STAFF REPORT
COMMUNITY DEVELOPMENT DEPARTMENT

HEARING DATE: 11/16/2021
 TO: Mayor & City Council
 FROM: Joe Dodson, Associate Planner
 208-884-5533
 SUBJECT: H-2021-0046
 Centerville Subdivision
 LOCATION: The site is located at 4111 E. Amity Road (including the outparcel to the south) and 5200 S. Hillsdale Avenue, at the southeast corner of S. Hillsdale and E. Amity, in the NW ¼ of the NE ¼ of Section 33, Township 3N., Range 1E.

Annexation & Zoning of 40.49 acres of land from RUT to the R-8 (13.35 acres) and R-15 (27.14) zoning districts with a concept plan showing 159 single-family units and 168 multi-family units and a preliminary plat consisting of 190 total lots (124 single-family residential lots, 35 townhome lots, 2 multi-family lots, 1 commercial lot, 1 clubhouse house, and 27 common lots) on 38.95 acres of land.

D. Landscape Plans (date: ~~6/07/2021~~ 10/15/2021)

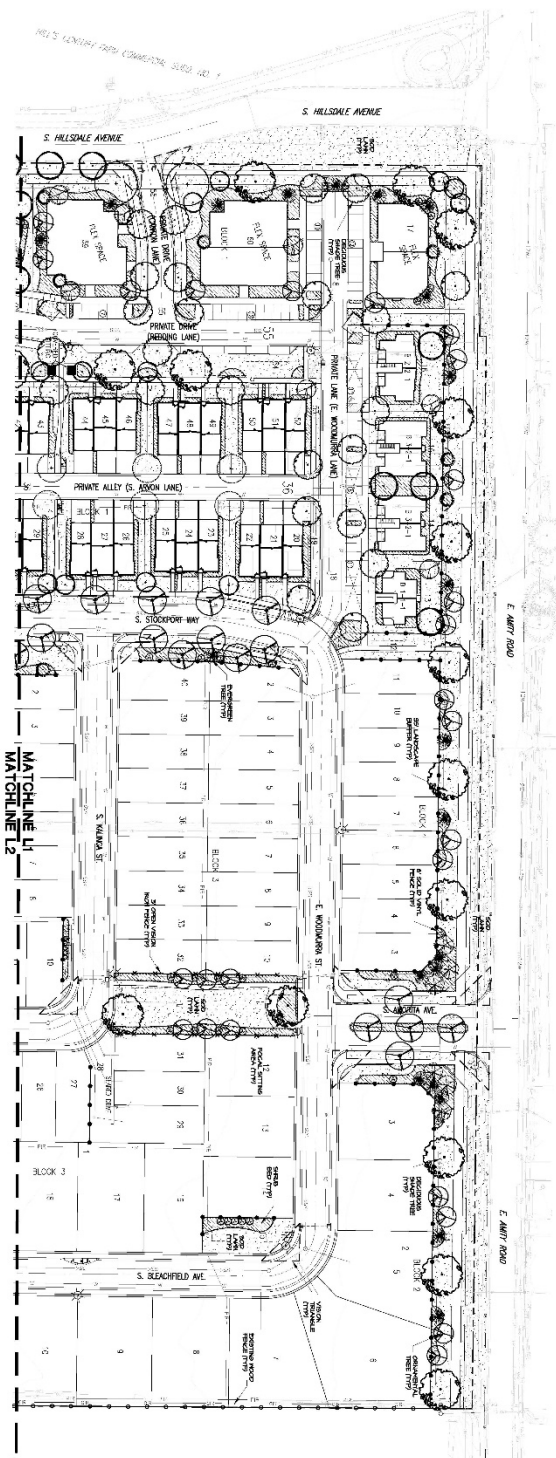
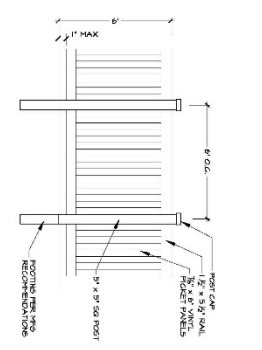
Landscaping is required along all pathways (including micro-pathways) in accord with the standards listed in *UDC 11-3B-12C*. The total lineal feet of *all* pathways with the required and proposed number of trees are not included in the Landscape Calculations table on the submitted landscape plans. This should be corrected prior to Final Plat submittal. However, the correct number of trees appear to be shown on the submitted plans. *The Applicant has proposed a micro-path in the southeast corner of the site to connect two blocks and the correct number of trees is shown on the landscape plans but there are no trees shown adjacent to the pathway to offer any shade. The pathway segment is slight over 100' which requires only one tree adjacent so the Applicant should move one tree from a portion of this common lot and place it next to the pathway to comply with UDC 11-3B-12C.*

3. The landscape plan included in Section VII.D, dated ~~June 7, 2021~~ October 15, 2021, is approved as submitted. shall be revised as follows at least ten (10) days prior to the City Council hearing:

- a. ~~Revise the landscape plans to match the revised preliminary plat;~~
 - b. ~~Per UDC 11-3B-12C, place at least one tree along the micro-path located on Lot 30, Block 5, as labeled on the revised preliminary plat.~~

E. Proposed Phasing Plan

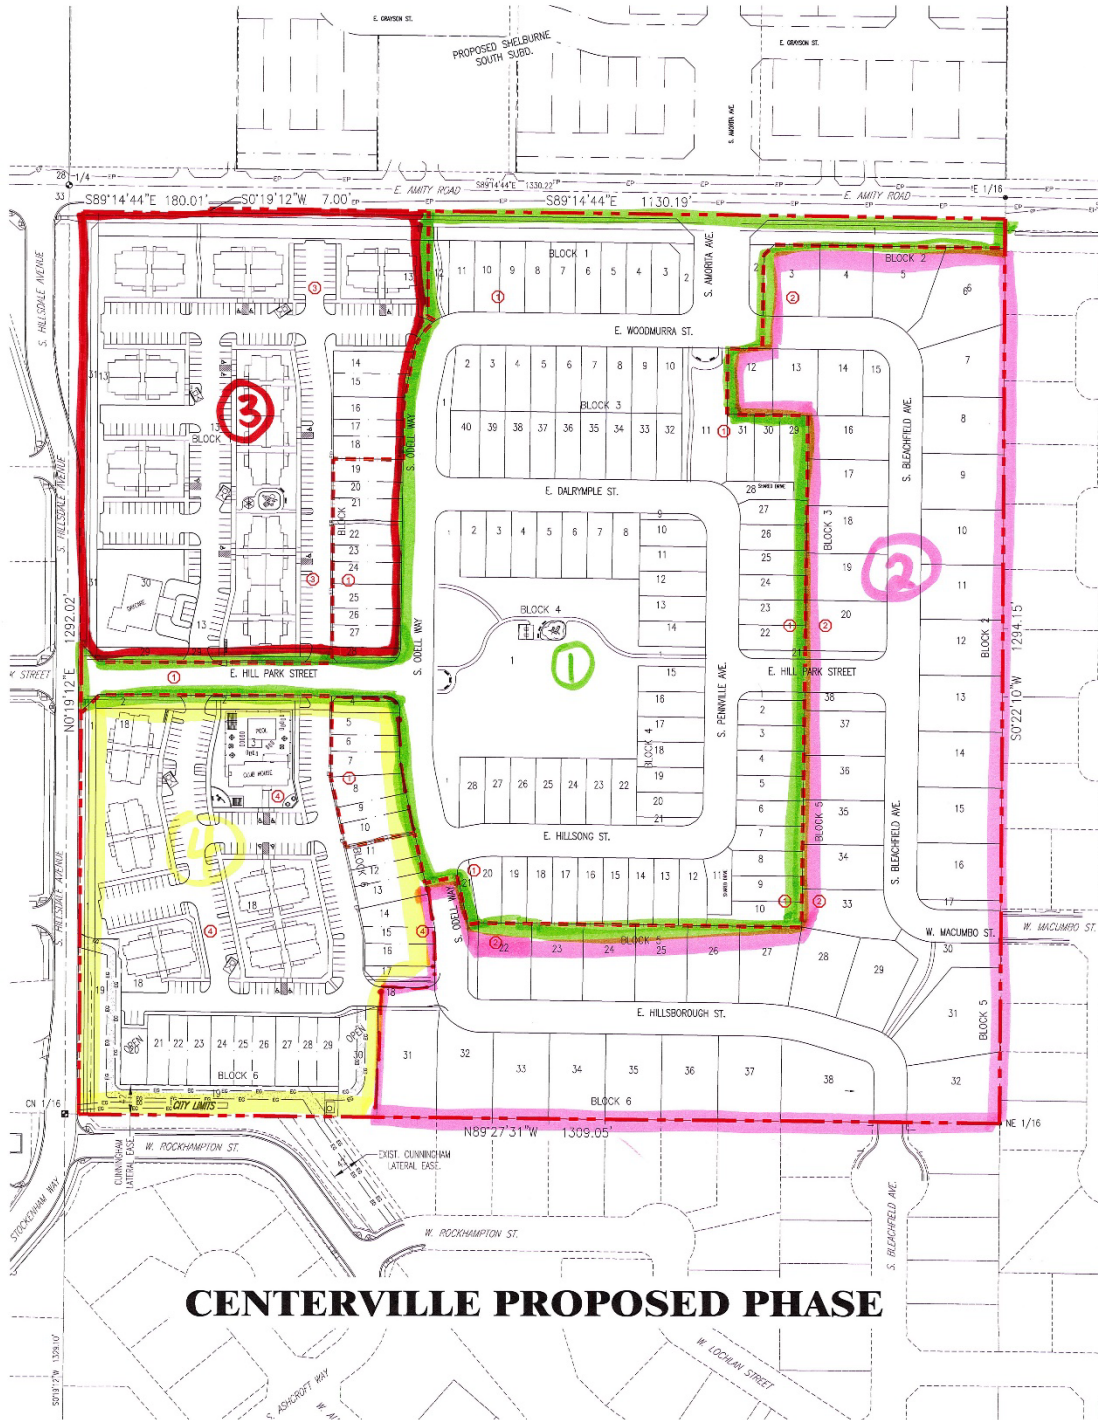
The Applicant has provided a phasing plan notating the project is to be constructed in four (4) phases and shows a majority of the single-family portion of the site to be developed in the first two phases and includes the accesses to Amity and Hillsdale Ave. and the large central open space in the first phase of development. The phasing plan shows the extension of the existing stub streets into the site and the remaining detached single-family occurring with the second phase of development. A majority of the multi-family is proposed with phase 3 and would also include the daycare facility. Lastly, the proposed clubhouse and pool, the remaining multi-family, and the only front-loaded townhomes (at the very southwest corner of the site) is proposed with the fourth and final phase of development and is located in the southwest quadrant of the project.

- b. Future development shall be generally consistent with the proposed phasing plan, specifically that no more than 30 homes shall be constructed prior to both the Hillsdale Avenue and the Amity Road accesses being constructed.

F. Common Drive Exhibits

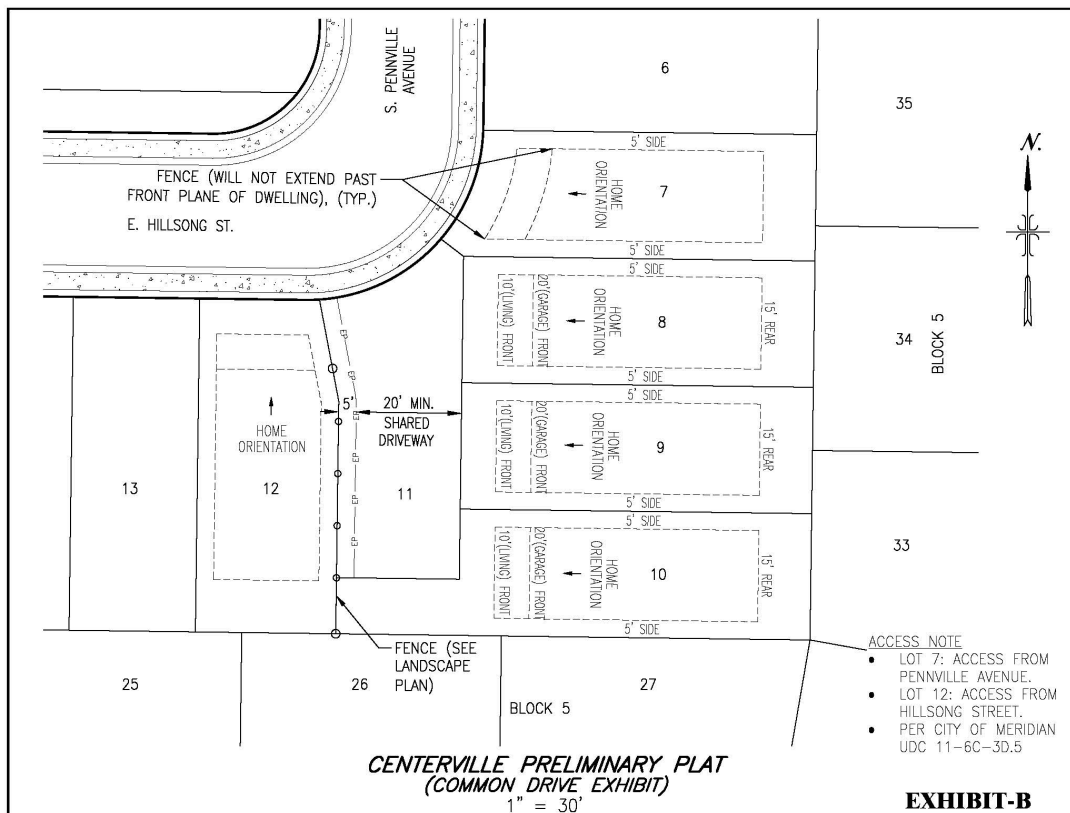
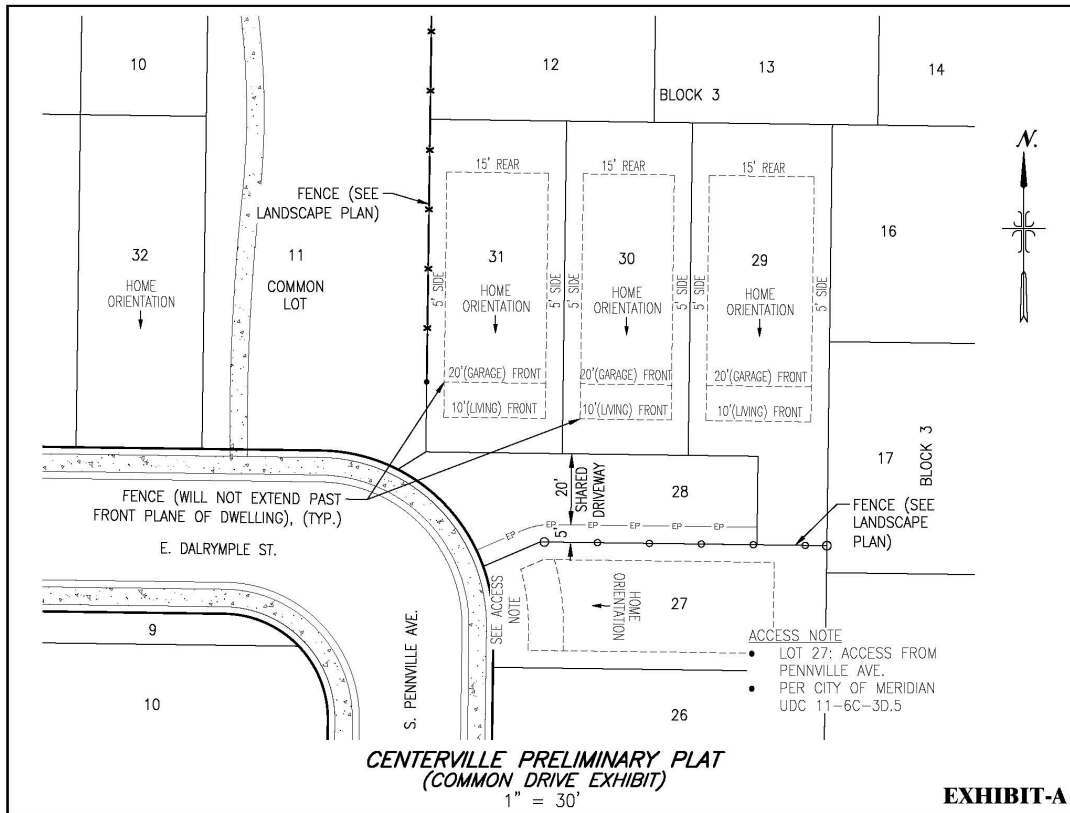
The Applicant has proposed two common driveways as part of the detached single-family portion of the site (Lot 28, Block 3 & Lot 11, Block 5). Code has recently been revised to limit the number of units taking access from a common drive to four (4) total units, with no more than three (3) being allowed on one side of the drive. The submitted preliminary plat shows three (3) units taking access from each common drive.
